PETITION #2019-039  
MALLARD CREEK NEIGHBORHOOD  
CHARLOTTE, NORTH CAROLINA  
DEPENDABLE DEVELOPMENT, INC.

# Rezoning Transportation Analysis

Petition Number: 2019-039

## DPR Response Letter: 2019-07-16

RZ-1

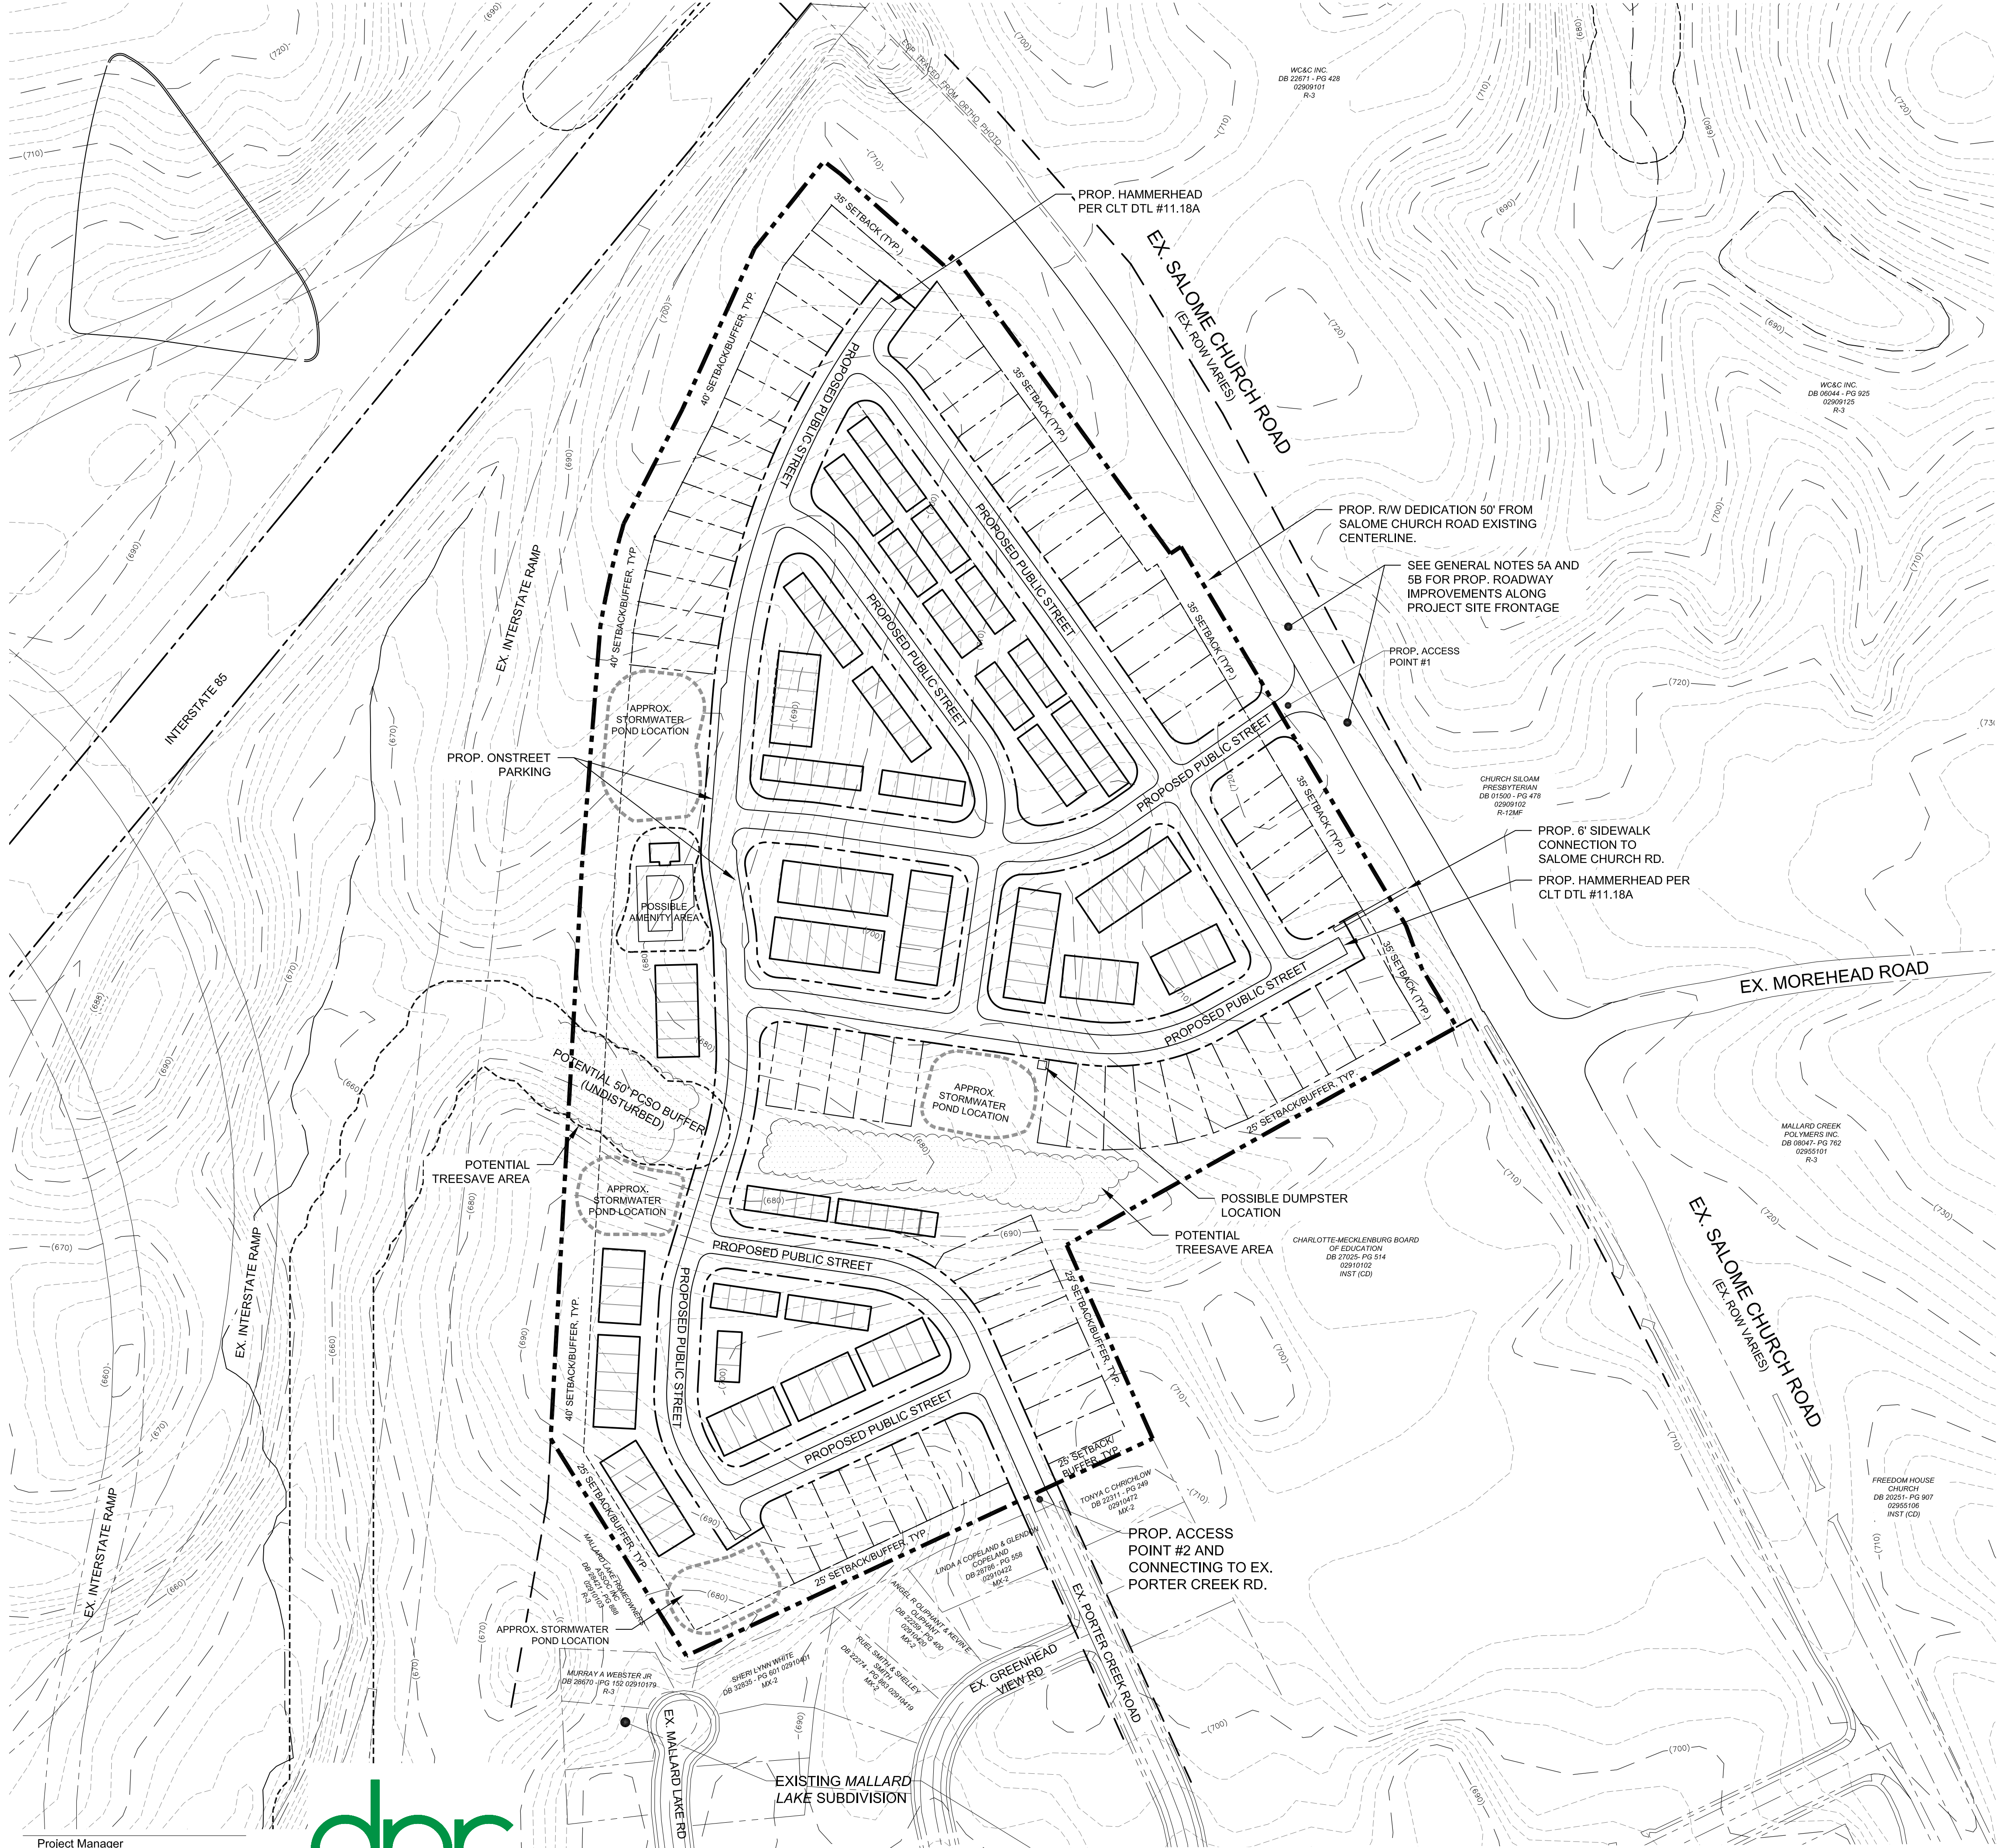
1. **Curbline:** The proposed zoning district has a setback measured from back of the existing or proposed future right-of-way line. The location of the future back-of-curb for:

- Salome Church Road – 30 feet as measured from the road's existing centerline. The petitioner should update the site plan to commit to construct the curb and gutter at the location mentioned above. The site plan should label and dimension the curb and gutter from the road centerline.

2. ~~**Traffic Study:** A Traffic Impact Study is not necessary for the complete review of this petition.~~
3. The petitioner should revise the site plan and conditional note(s) to specify and implement a 12' multi-use path, 8' planting strip, and 2.5' curb and gutter along the site's Salome Church Road frontage and extending to the I-85 bridge.

5. **Comment revised.** The petitioner should revise the site plan and conditional note(s) to commit to asymmetric **symmetric** off-site roadway improvements, to provide two 11' wide southbound travel lanes, **one north bound travel lane**, and a northbound 11' left turn lane on Salome Church Rd. at the proposed access location. The left turn lane should provide 100' of storage capacity and a 100' bay taper.

DPR Response: Done. See revised Note.
8. ~~The petitioner should revise the site plan to add a note specifying dedication and fee simple conveyance of all rights of way to the City before the site's first building certificate of occupancy is issued. CDOT requests a sidewalk utility easement at 2' behind back-of-sidewalk.~~
9. **New Comment:** The petitioner should revise the site plan's note 5.B, to specify that **all transportation improvements will be approved and constructed before the site's first building certificate of occupancy is issued.**

DPR Response: Done. See revised Note. CDOT & Petitioner agreed on 40<sup>th</sup> Building CO.
10. ~~The petitioner should revise site plan note 5D to state the petitioner commits to implementing traffic calming measures, including three (3) speed humps, stop signs, and 25 mph speed limit signs within the subdivision. These devices will be funded by the petitioner and their placement will be determined during the permitting process.~~
11. ~~The petitioner should revise the site plan to implement on-street recessed parking on both sides of the proposed public street that fronts the possible amenity area. Accessible on-street parking spaces should also be provided on both sides of the proposed public street.~~

DPR Response: Done. See revised Note. We added "asymmetric or symmetric" per our agreement at the meeting w/ Rick, Eric.
6. ~~The petitioner should revise the site plan and conditional note(s) to include the proposed public street connection to existing Porter Creek Road.~~
7. **Comment revised.** The petitioner should revise the site plan and conditional note(s) to specify and provide an 8' planting strip and **(6')** 8' sidewalk throughout the entire subdivision. Also, the 8' planting strips and **(6')** sidewalks along the site's proposed southern public street need to be extend to Salome Church Rd's 12' multi-use path. ~~This pedestrian connection will provide a direct pedestrian/bike connection to Salome Church Rd. and provide pedestrian access to Stoney Creek Elementary.~~
